INITIAL FIRE SAFETY INSPECTION REPORT

Factory Name: Scandex Textile Industries Ltd.

RSC ID: 24831

Date: 31 December 2023

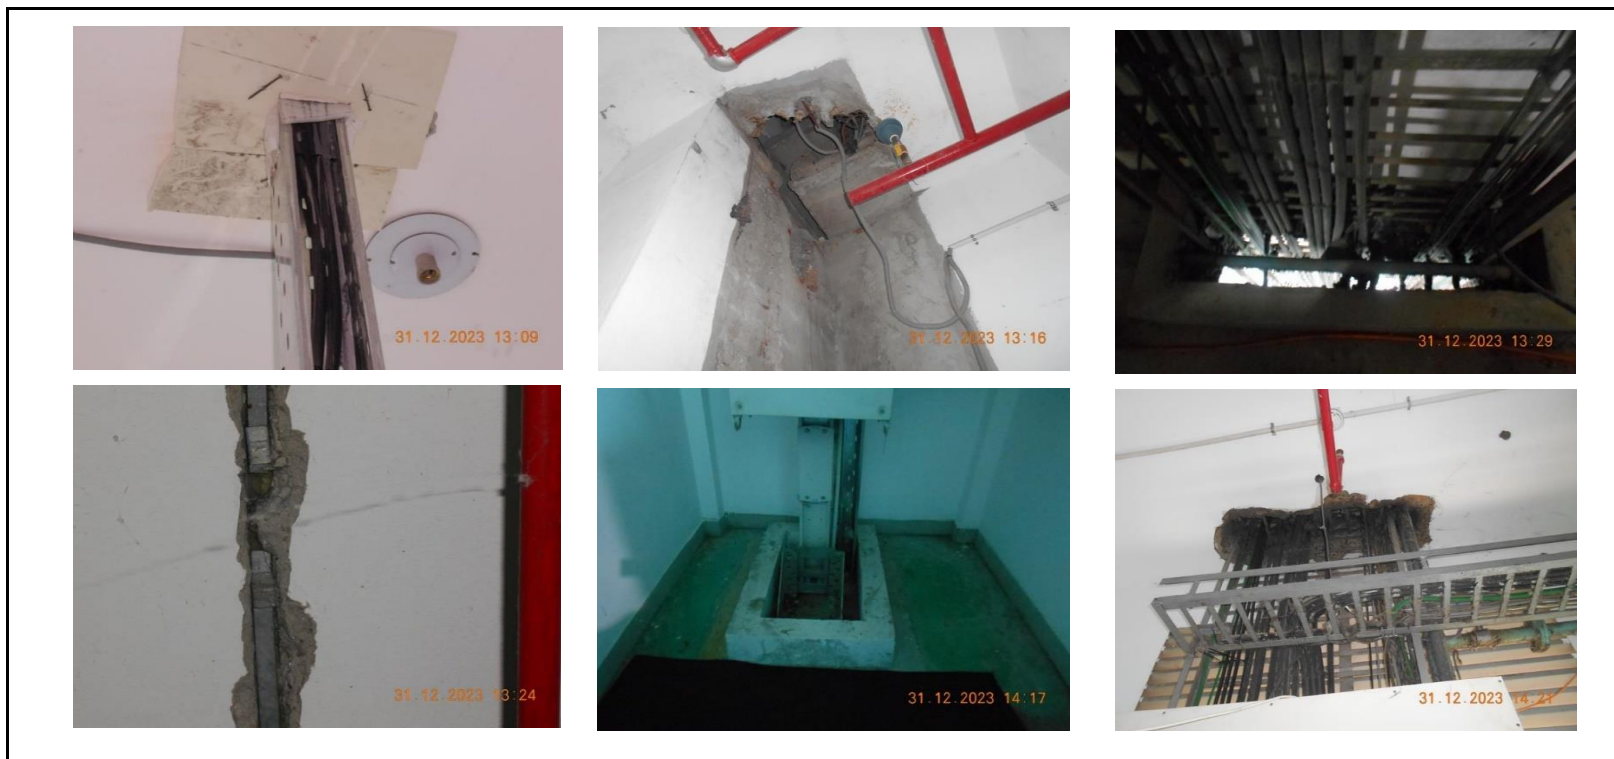
Sl No.	Category	Findings	Required Action	Remediation Time Frame
F-1	Fire Rated Construction	Building-01 and Building-04 The exit stairs are not separated from work areas, other spaces on each floor by fire-rated construction.	Provide minimum 2-hr fire rated construction for buildings 4 storied or more and 1-hr for upto 3 storied. Seal all unprotected openings to separate the exit stairs from work areas and other spaces on all floor levels by 90 minutes for 2 hr construction and 60 minutes for 1-hr construction. Ensure that the fire rated doors are self-closing and positive latching and that they are provided with fire exit (panic) hardware where serving production floors and provide vestibules to avoid direct discharge from storage to exit stair enclosure. If fire rated doors are required to be held open for functional reasons, provide automatic closing devices tied to the fire alarm system. Once fire doors are installed, every door in a stair enclosure serving more than 5 stories shall be provided with re-entry unless it meets The RSC Technical Guidelines (Standard) 6.8.3.1	Within 3 months

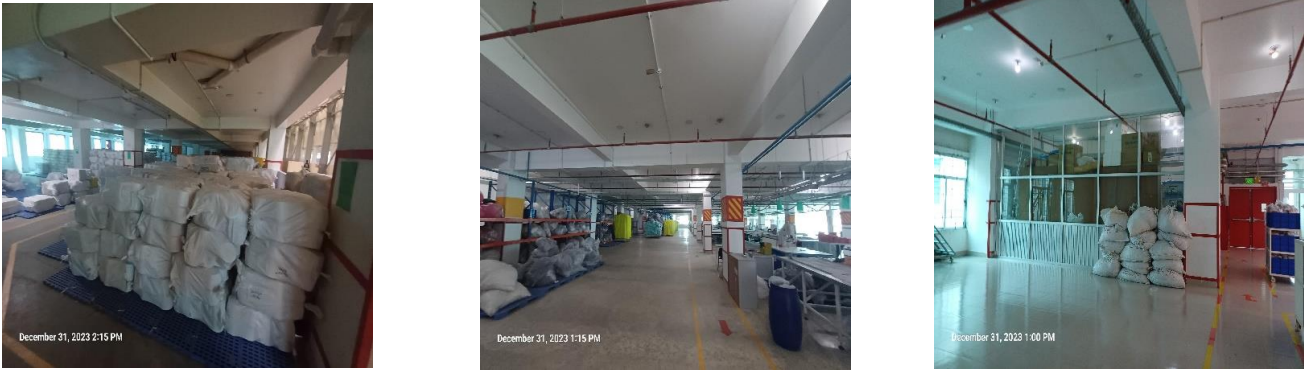
F-31	Fire Rated Construction	Building-03 The main structural elements of factory building are constructed by steel which is non-rated structure and were found in exposed condition without any fire protection.	For interim construction, the building shall be Type 1 or Type 2 construction as required in BNBC 2006 Part 3 Table 3.2.4. So, provide require rating for the structural elements of the building following BNBC 2006-Table 3.2.4, 3.1.9 and 3.3.1. Factory shall ensure that, all the design, datasheet, certificate, and the design-philosophy has been reviewed from the RSC prior to install the passive fire protection system.	Within 6 months
------	-------------------------	--	--	-----------------

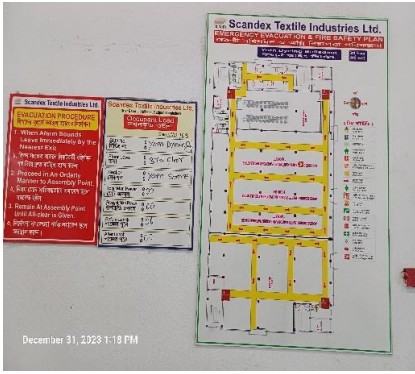
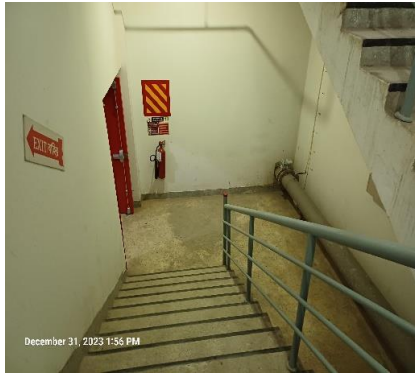
F-32	Fire Rated Construction	Building-03 Elevator shafts are directly open into the inside of exit enclosure on several floors.	An exit stairway shall not be built around a lift shaft unless both of them are located in a smoke proof enclosure and made of a material with fire resistance rating required for the type of construction of smoke proof enclosure. So, ensure the lift shaft is 2-hr fire rated including opening protection with similar rating.	Within 6 months
------	-------------------------	---	---	-----------------
